Buncombe County Planning Board August 1, 2016

SUB2016-00274: Harlow L. Brown, P.E. on behalf of Doug Thompson applied for major subdivision approval of 14 lots for the project identified as Saddle Ridge Estates, and located on tax lot PIN # 9712-88-5975 (further described as un-addressed property to the east of 91 Cody Embler Road).

Buncombe County Planning Board Meeting Recommended Staff Conditions August 1, 2016 SUB2016-00274 (Saddle Ridge Estates)

SADDLE RIDGE ESTATES
for
VIEWPOINT OF NC, LLC
in
ALEXANDER NC

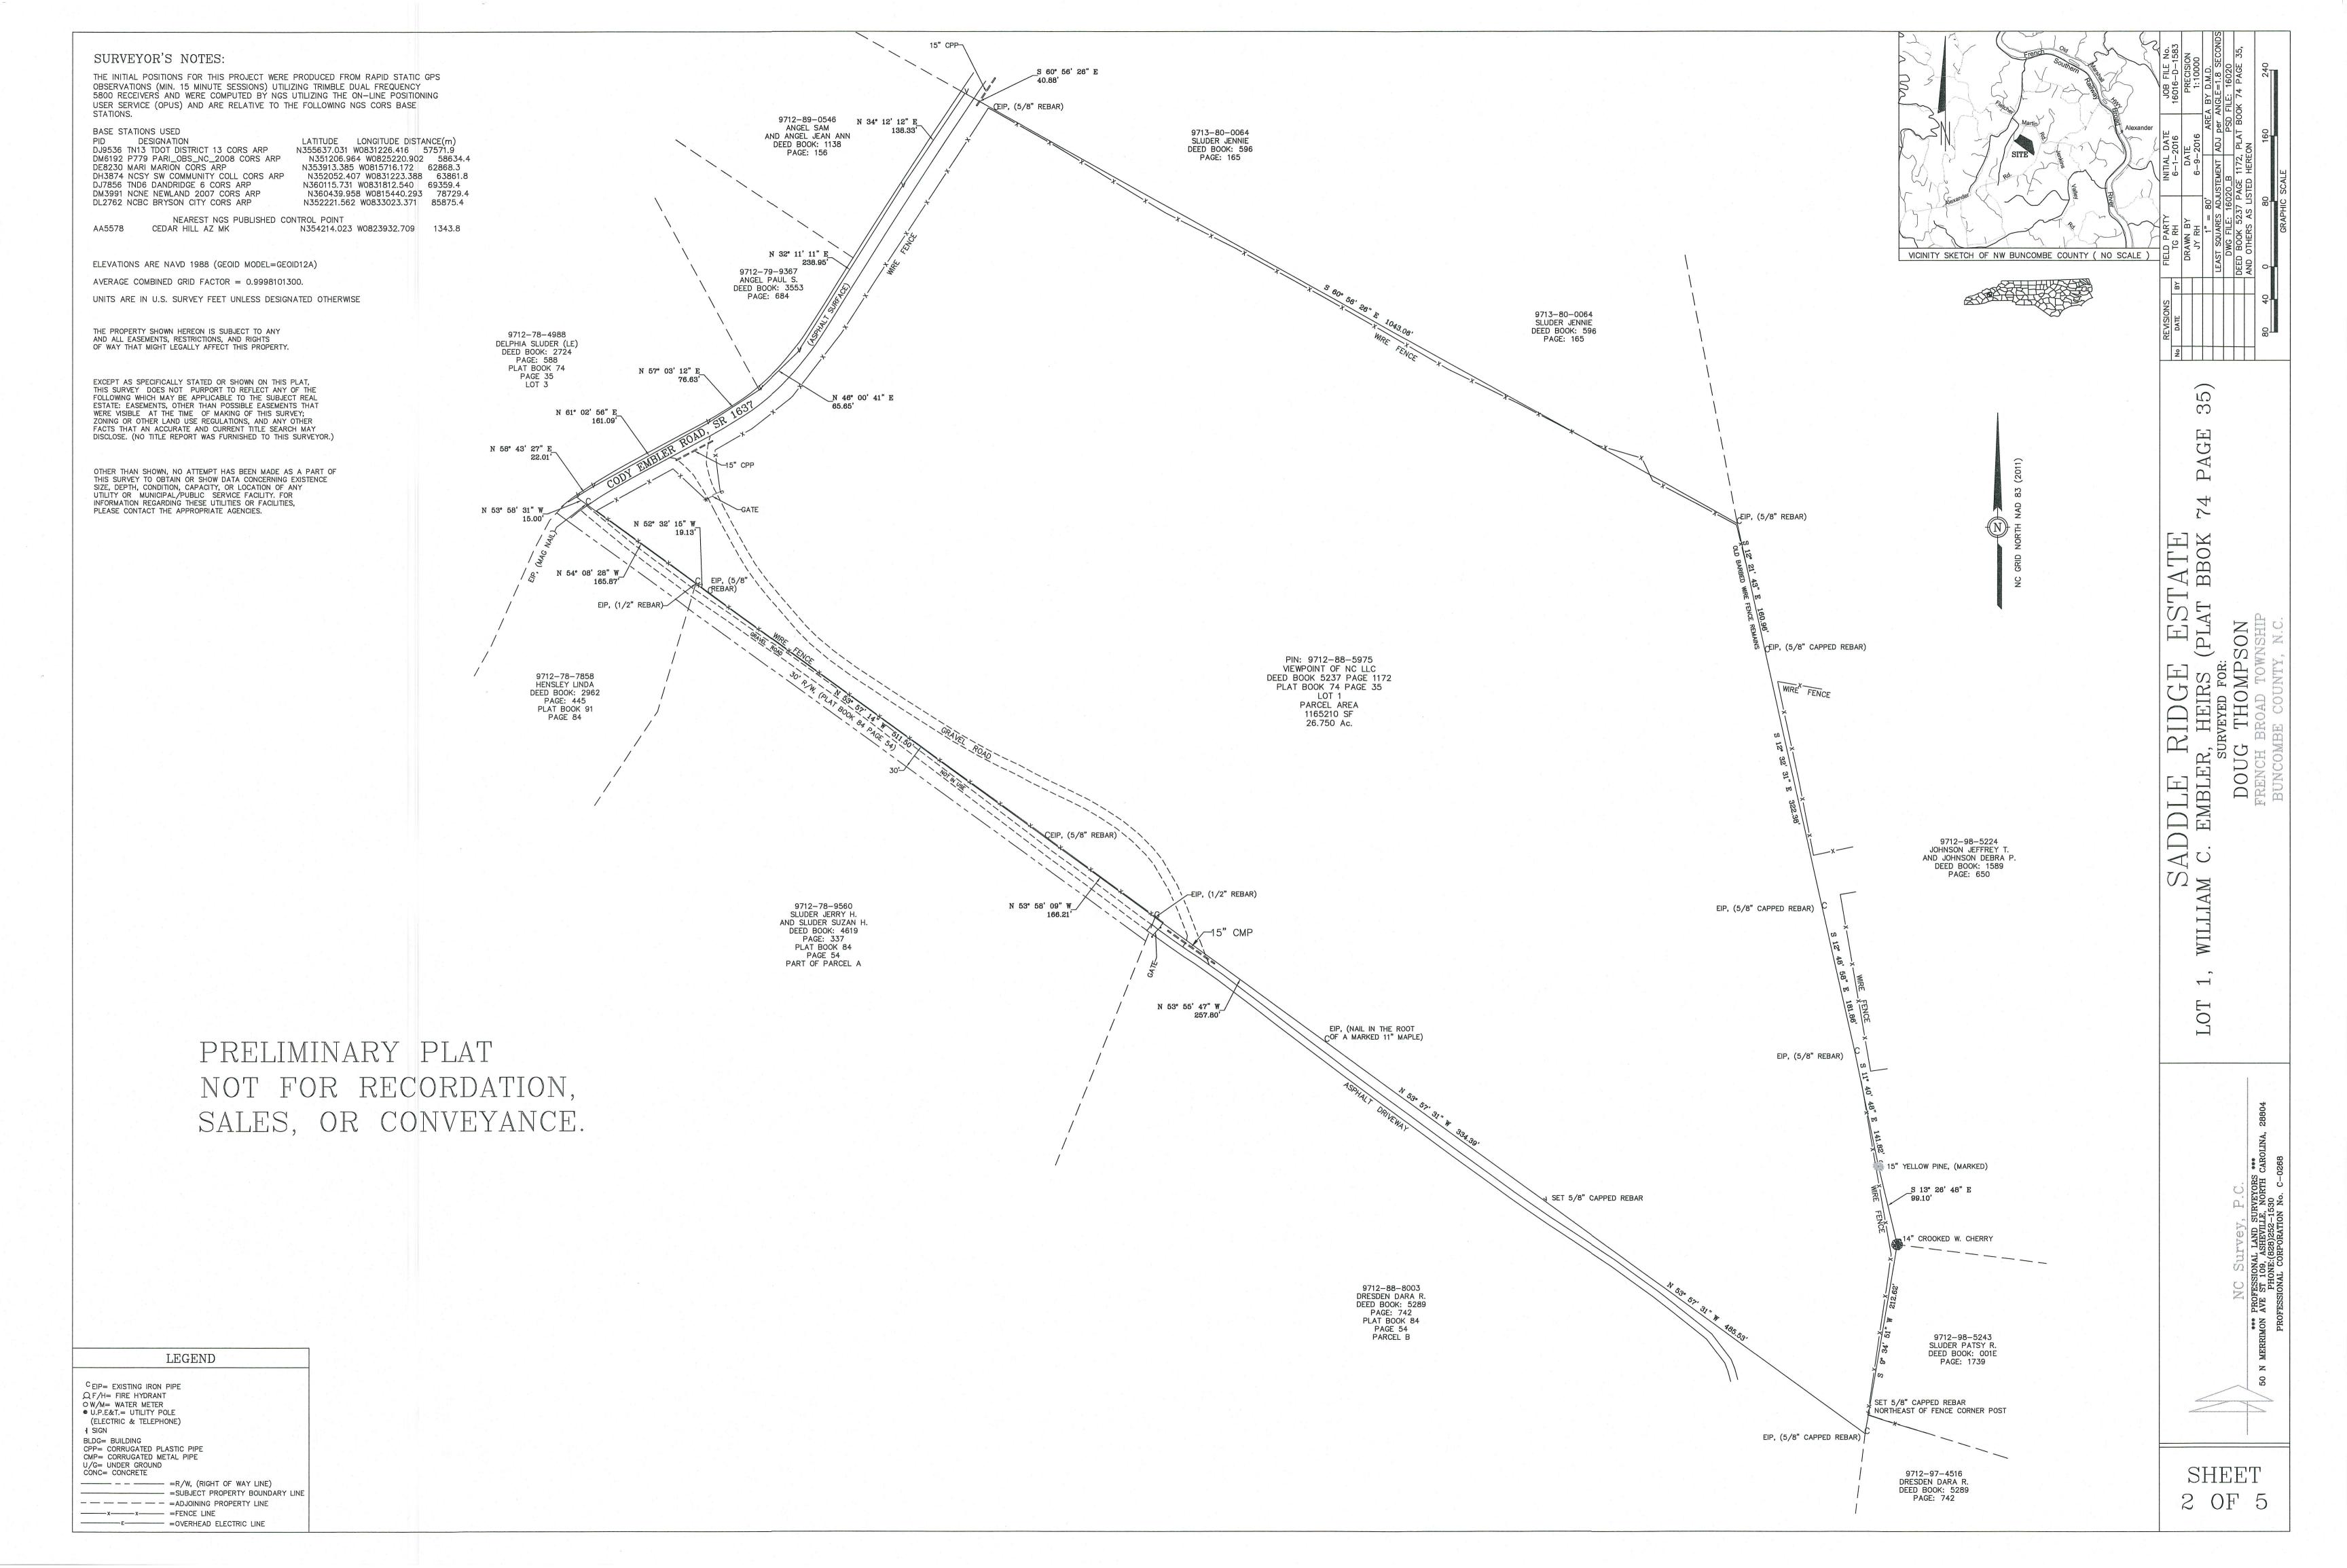
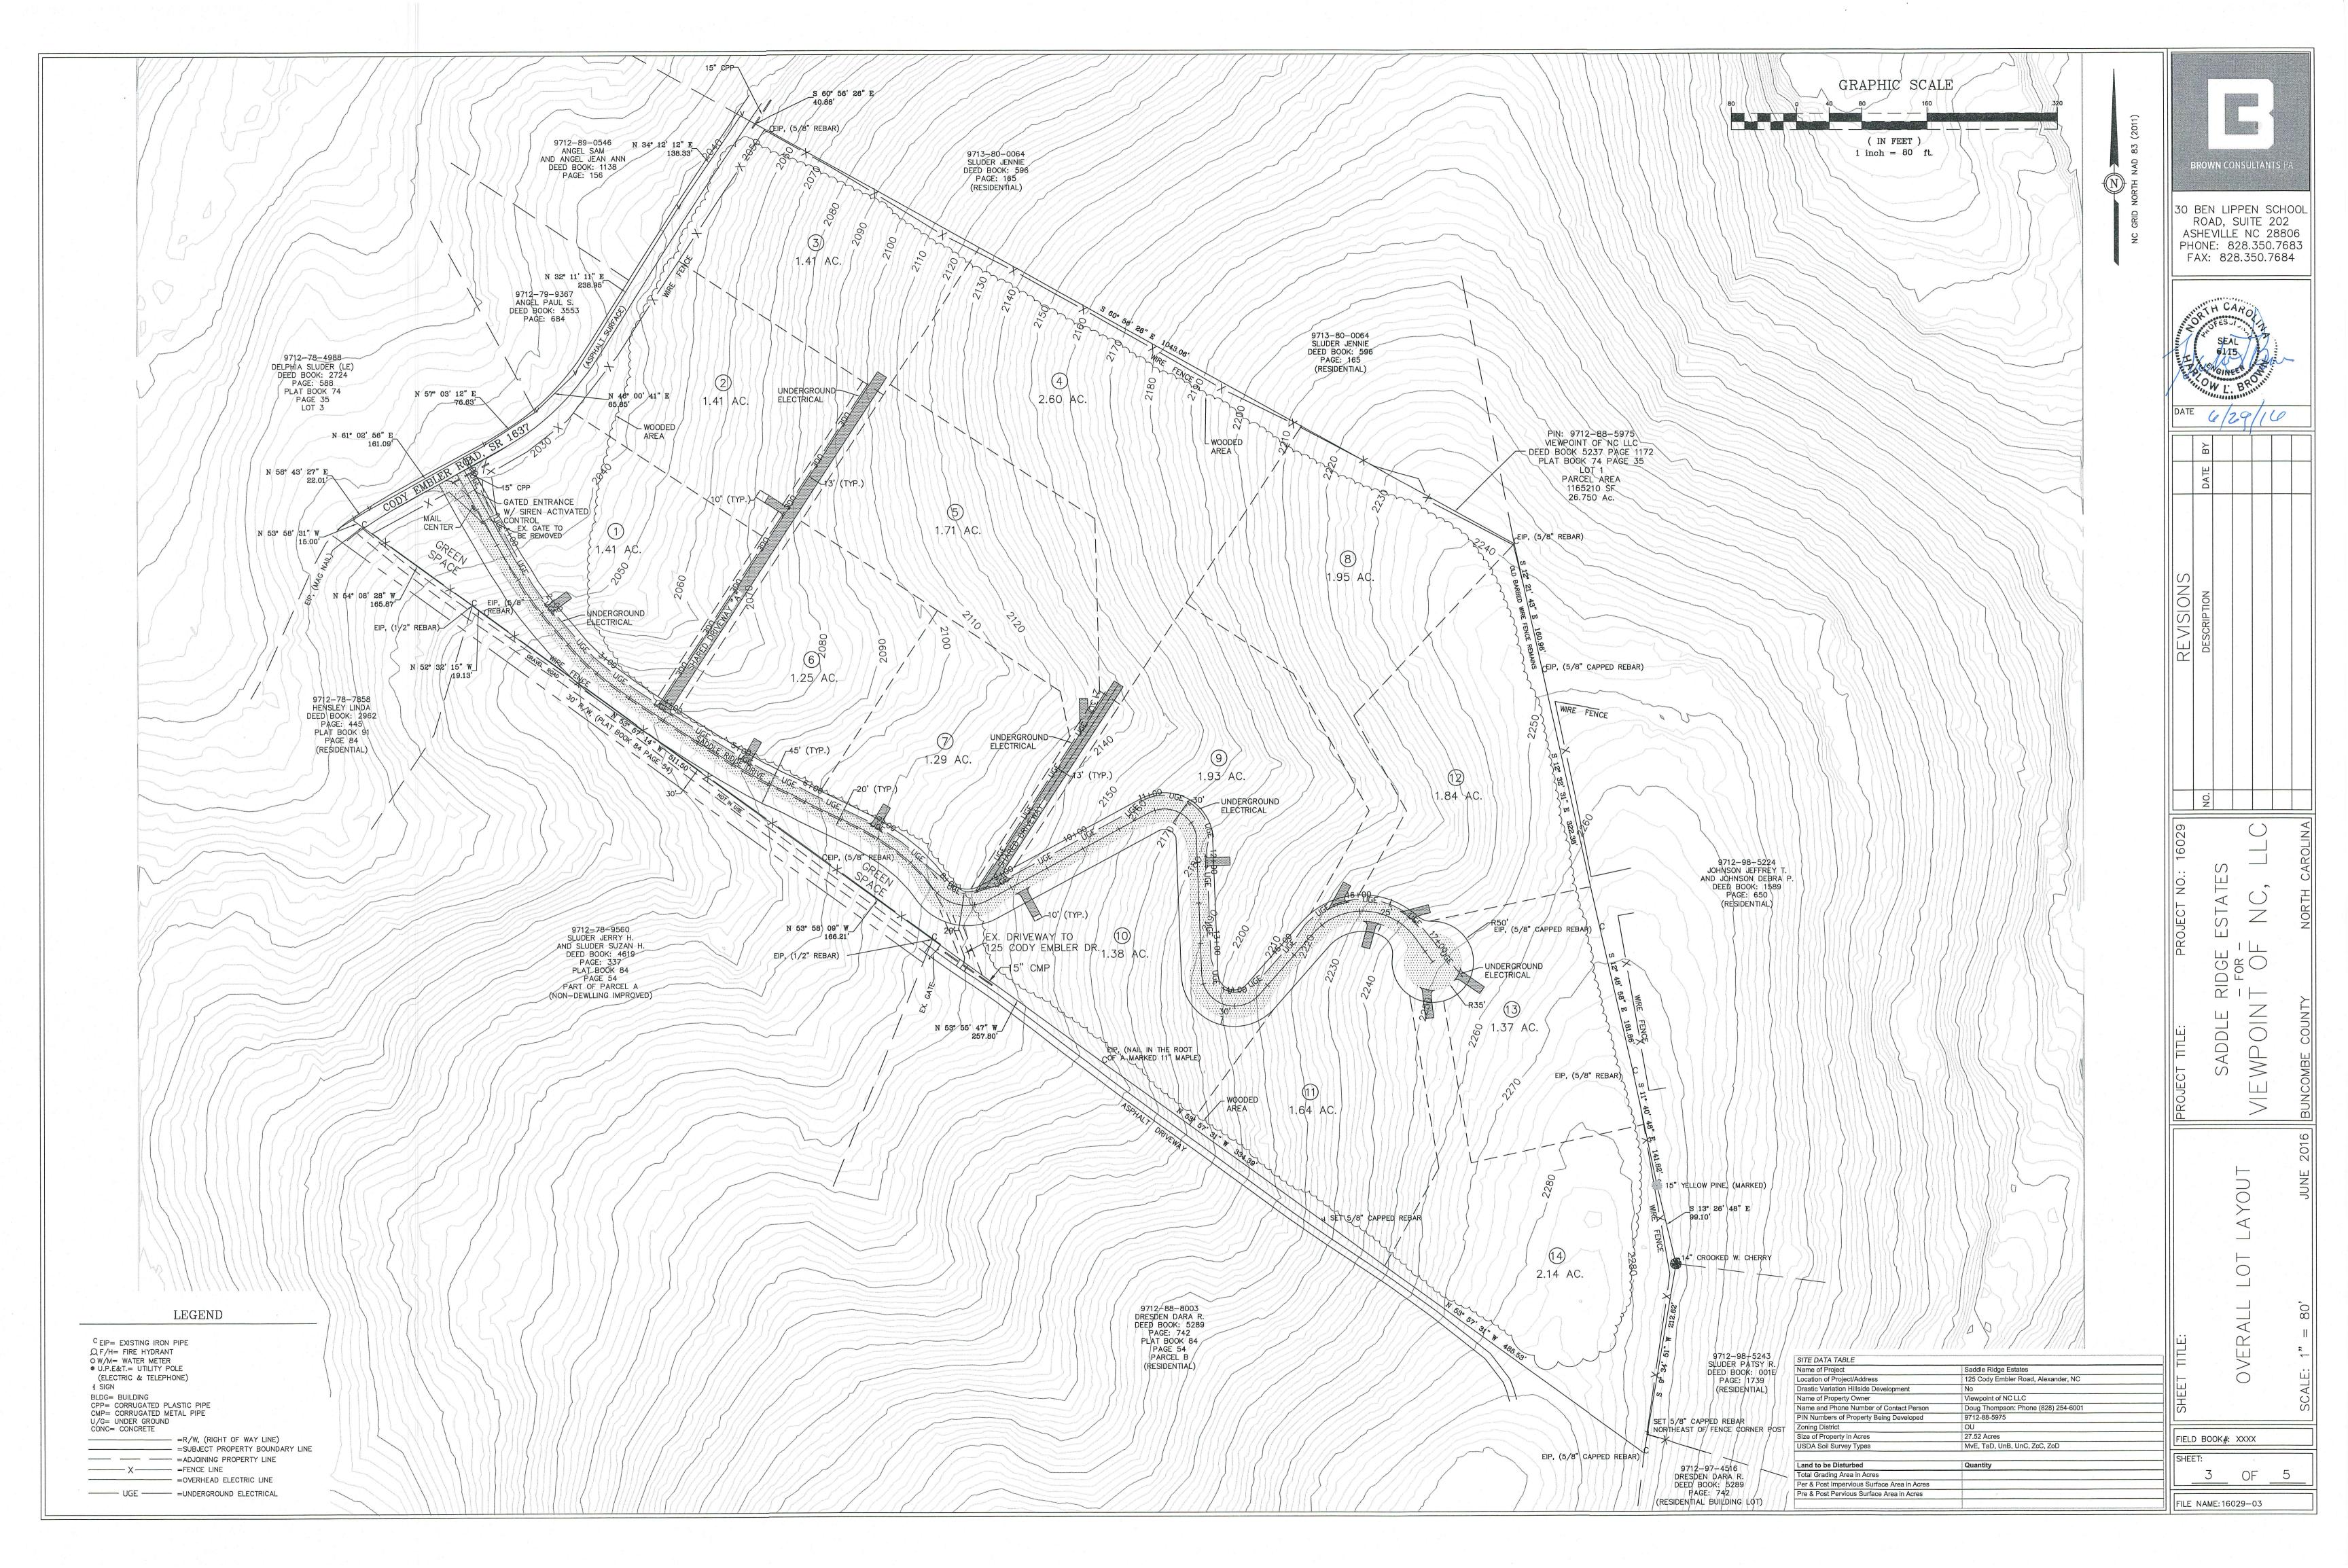
If approved by the Buncombe County Planning Board, the applicant shall provide the following information on a revised set of plans (if necessary) submitted to the Buncombe County Department of Planning and Development:

Provide proof of approval of E-911 addressing
 Provide a written statement from the Buncombe County Erosion Control Officer stating that an Erosion Control Plan has been has been submitted and approved for the project. No grading shall occur on the site until an approved Buncombe County Erosion Control permit is obtained.
 Provide a written statement from the Buncombe County Stormwater Administrator stating that the approved Stormwater Plan has been submitted and approved for the project. No grading shall occur on the site until an approved Buncombe County Stormwater Control permit is

4. Provide proof of a preliminary soils investigation that will evaluate the feasibility of developing a subdivision served by individual septic systems, which shall be prepared by a professional such as a soils engineer or soils scientist.

- 5. Indicate lot slope perpendicular to the roads for each lot or indicate that lot slope perpendicular to the road for all lots is less than 18%.
- Indicate FEMA floodplain map information on the submitted plan.Indicate address of property owners on submitted plan.
- 8. Indicate township on submitted plan.
- 9. Indicate township on submitted plan.
 9. Indicate provision of utilities, or indicate that no such provision are provided on submitted
- 10. Indicate approximate delineation of wooded and open areas on the submitted plans.

11. Indicate that no base course shall be placed on muck, pipe clay, organic matter or other unsuitable matter, and a minimum compaction rate of subgrade prior to paving shall not be less than 95 percent by standard proctor method and certified by a licensed engineer.
- 12. Indicate linear feet of roads on the submitted plans.13. Indicate existing use of the subject property on the submitted plans.
- 14. Indicate curve radii on submitted plan. Increase pavement width and base course where the road centerline is less than a 90-foot radius.

feet. Indicate that the corridor height does not exceed 60 feet on the submitted plans.

15. Provide proof of consultation with a geotechnical engineer for road construction in areas of a tract in excess of 30 percent natural slope and for all areas designated as High Hazard or Moderate Hazard on the Buncombe County Slope Stability Index Map prepared by the North Carolina Geological Survey or indicate that no such areas exist on the submitted plan.

16. Indicate that the road corridor does not exceed 90 feet in width along 80% of its total

length; up to 20% of the length of the road corridor may be graded to a maximum width of 135

17. Indicate construction of shared driveways on the submitted plans.
